Subject: Oyster Creek Nuclear Generating Station (OCNGS)
Docket No. 50-219
Reload Topical Report 045

OYSTER CREEK NUCLEAR GENERATING STATION
GPU NUCLEAR TOPICAL REPORT 045
RESPONSE TO NRC REQUEST FOR ADDITIONAL INFORMATION
DATED MAY 12, 1988

REVIEW QUESTIONS ON THE GPU TOPICAL REPORT TR-045

Figure 1 – Basic Hot Channel Model

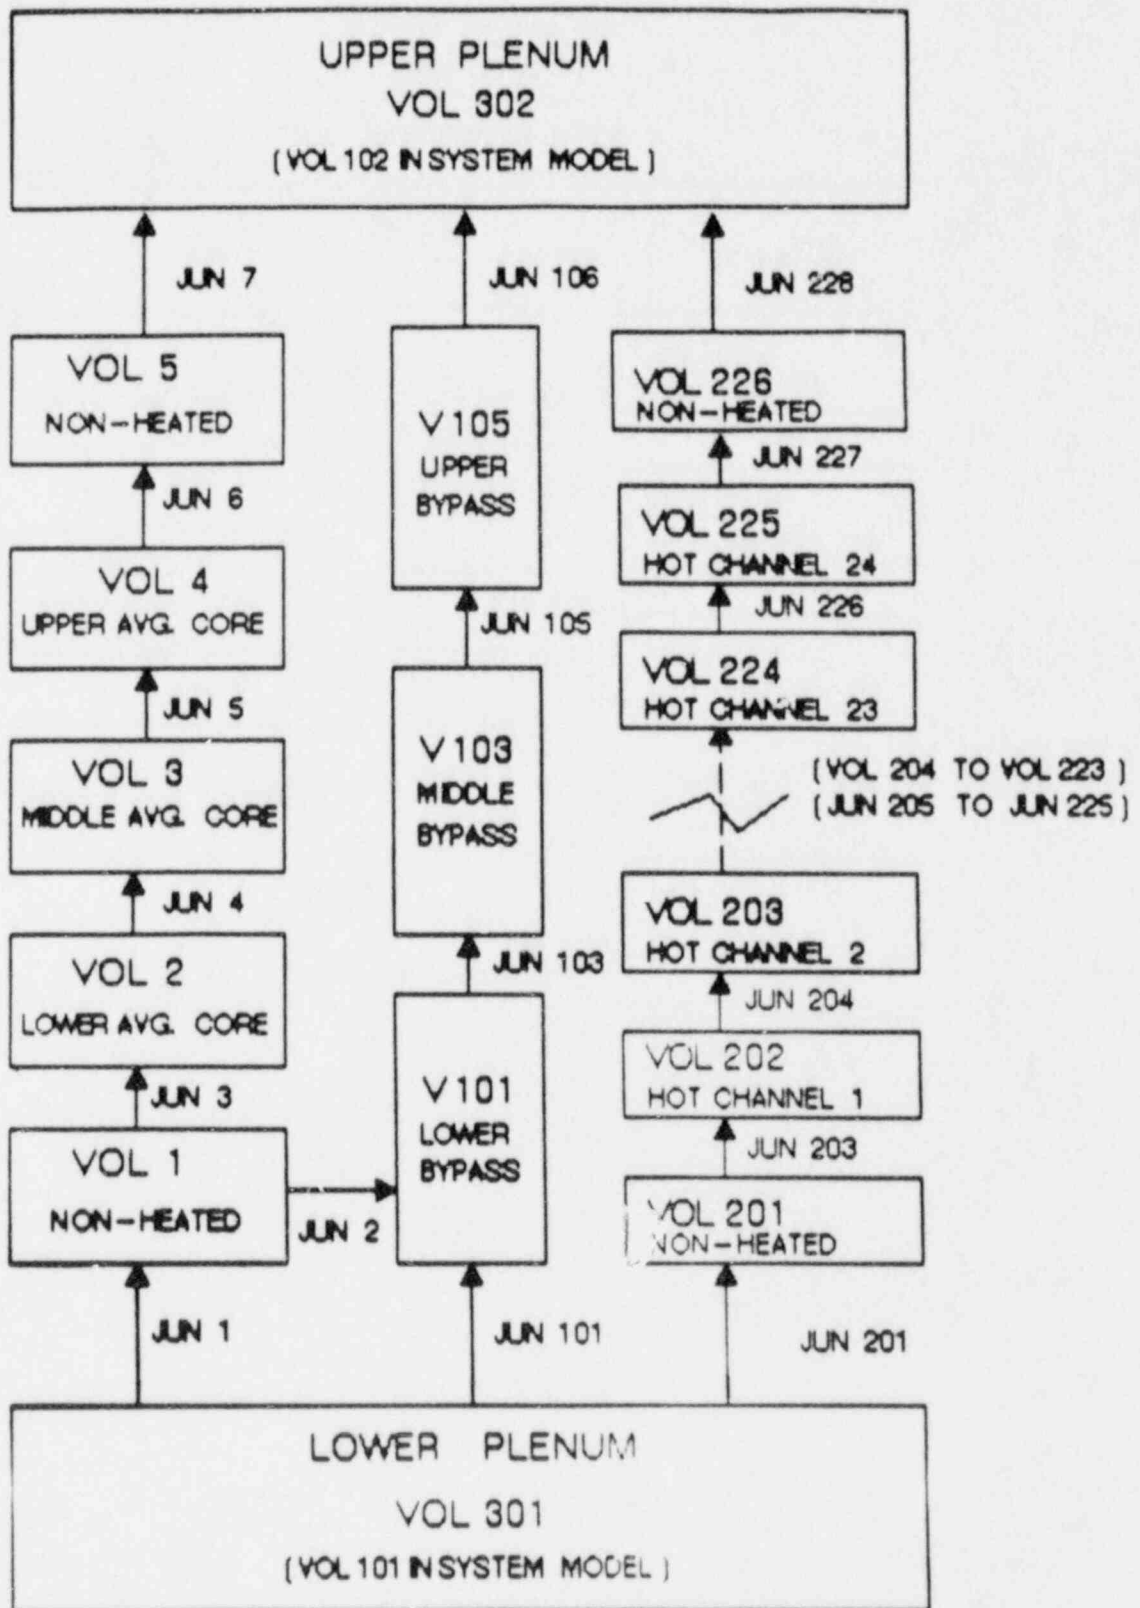
1. Provide a detailed description of GPU's RETRAN hot channel model including justification of the void, flow and pressure profiles, and explain how his model is interfaced with the GEXL correlation computation. What is the "core 3-D simulator model" which is used to obtain the hot channel flow?

The Hot Channel Model is described in Section 2.1.2 of TR-045. A nodding diagram is attached (Figure 1). The steady state and transient void, pressure and flow values are taken from the system model for the upper and lower plena. Steady state and transient power profile is also taken from the system model for the transient investigated. The output of the Hot Channel Model required for CPR calculation consists of core average pressure, hot channel flow, core inlet subcooling (or enthalpy) and hot channel power as a function of time during the transient. These parameters are then used in "RACE"⁽¹⁾ which is a GPUN code where the GEXL correlation is coded for transient and static CPR calculation. The justification of the axial power profile for the hot bundle (axial peaking of 1.4 - Table 4.6 of TR-045) is based upon the usual profile used by GE in NEDO24195 for Oyster Creek past reloads where the same profile has been used in RETRAN Hot Channel Model and in RACE. The Core 3-D Simulator Model which is used to obtain the steady state hot channel flow is the integrated NODE-B/THERM-B⁽²⁾ which has been previously approved for thermal-hydraulic calculations representing the steady state behavior of the Oyster Creek Core. Once the hot bundle power and its axial profile are known (core average volumes power profile calculated from system model), hot bundle flow, bypass flow, upper and lower plena hydraulic conditions are determined, and the hot channel model is completely described.

Figure 2 - Bypass Valve Test

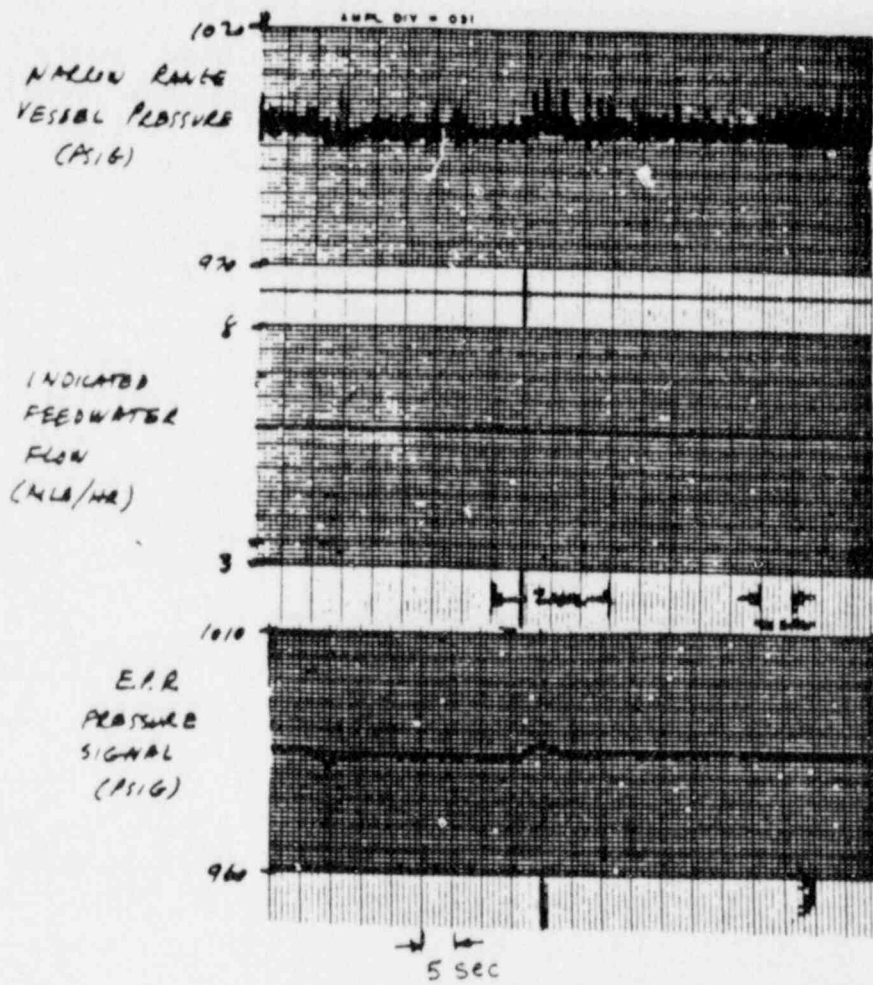
9. Explain why (a) the plots provided in the report indicate nearly 35% difference between the computed and measured changes in pressure signal data, and (b) the RETRAN model appears to have too much hysteresis as compared to the bypass valve test data.

- (a) The peak dome pressure change given by RETRAN in Figure 3.4.1 for the bypass valve test was 3.5 psi compared to 3 psi given by plant data. This shows approximately 15% margin for plant data relative to RETRAN. The timing is off by about 2 sec. and if a similar measurement error is applied to the time scale, a better agreement would be obtained. The justification of time scale error bound is thought to be legitimate considering the available plant data for this test, shown in Figure 2.
- (b) The Hysteresis effect may be amplified in the figures, but a closer look at plant data, Figure 2, shows the difficulty in arriving at this observation considering the noise level on the output and the signal magnitude of 3 psi out of an operating pressure of 1000 psi which puts it well within the uncertainty level of Table 1.0.

Figure 3

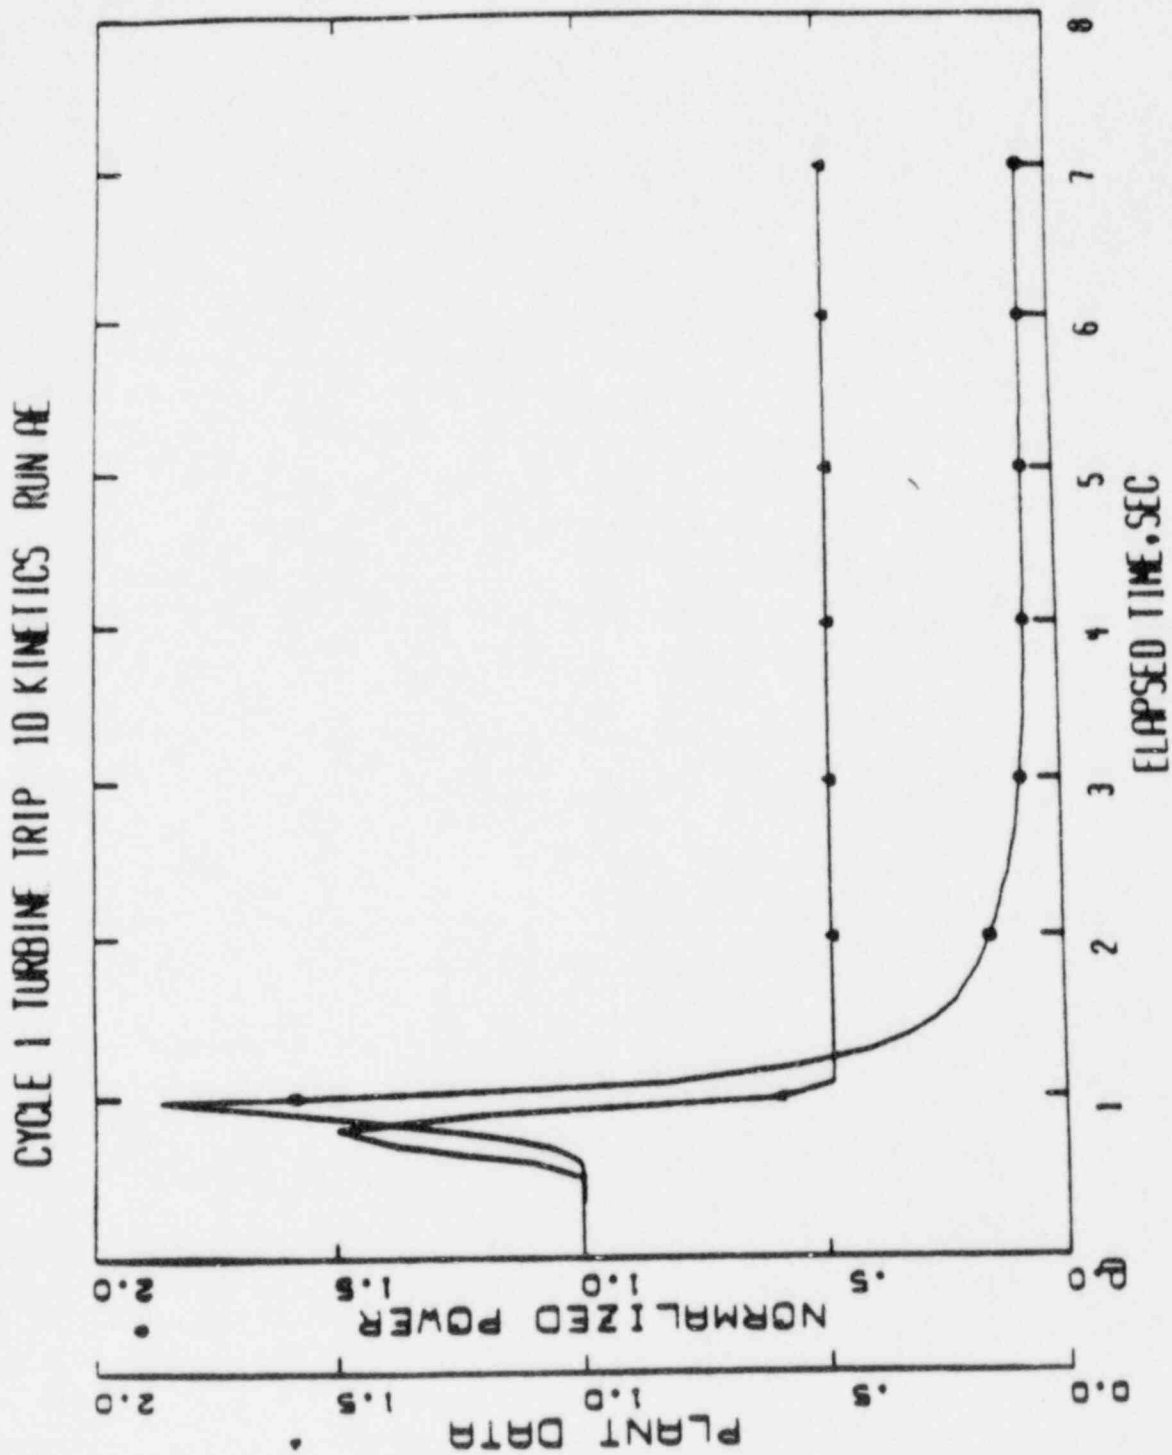
10. RETRAN underpredicted the dome pressure rise between 0.5 and 1.5 seconds, yet nearly double the power rise as compared to the turbine trip test data. This is an indication that the core T/H and physics computation may be inaccurate. Explain and justify the difference and how this would impact other transients.

The correlation between dome pressure and core neutronic power is influenced by certain characteristics of the regions between the dome and the core. For the separator, an important contributing factor is the separator inlet inertia. Figures 3 and 4 are plots of an earlier model where the steam path length inside the separator was used for calculating the inlet junction inertia which resulted in a small inertia value. The plots show an earlier power rise and a better prediction for the pressure increase early in the transient, but underpredicted the peak dome pressure. The inertia was then recalculated using the liquid path resulting in a higher value which produced more energy and conservative peak dome pressure as shown in Figures 3.5.1 and 3.5.2 of TR-045, although the power peak is at the same level, but delayed. The Cycle 1 startup test scram model assumes all control rods move at the same time and at the same speed while in reality, all rods do not start at the same time and do not start moving with the same speed. This assumption tends to insert more scram reactivity in the beginning which would limit the void collapse positive reactivity produced by the pressure wave and hence causes a delay in the power increase and results in a higher peak in RETRAN. With the high control rod density of Cycle 1, this is an important contributing factor. This effect was also seen in the ODYN Topical Report, Volume 2, Section 3.1.3.2 for the Peach Bottom tests⁽⁵⁾ benchmark. The objective of the model, as required here, is to predict conservative peak power and peak pressure which has been demonstrated. The licensing model uses the vendor's supplied inertia which is still higher than the best estimate value and it also uses the same scram model assumption of all rods traveling at the same time. Therefore, the licensing model will produce even more conservative behavior (Section 4.1.2b).
